Fw: 3 Holme Close Hatfield AL10 9LQ - Proposed single story extension Daylight and Sunlight Matters

**3 Holme Close Hatfield AL10 9LQ
Daylight and Sunlight Matters**

Application For "Prior approval for the erection of a single storey rear extension measuring 6m in depth, 3.1m in height and 3m to the eaves"

Council Application Ref 6/2019/0102/PN8

Figure 19: A tunnel effect can occur if a window is obstructed by extensions on both sides

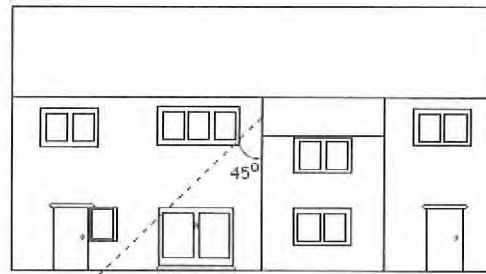
The above photograph of the existing situation and the BRE guidance figure 19 and clause 2.2.16 confirms that the applicant should not be permitted to create a large extension which creates a 'tunnel effect'. The impact of the new extension will have a detrimental cumulative effect on 2 Holme Close.

The BRE only permits a minor 20% reduction and as has been confirmed in the previous analysis, the impact will be significant and material. This is materially beyond the 20% reduction permitted by the BRE guidelines which is of course the reference document the Council use to assess impacts of development upon neighbour's amenity. As you are aware, the BRE Guidelines were written with a suburban environment in mind. Holme Close demonstrates those very characteristics and so there can be no good reasons why this proposal which reduces the neighbour's light can be considered acceptable.
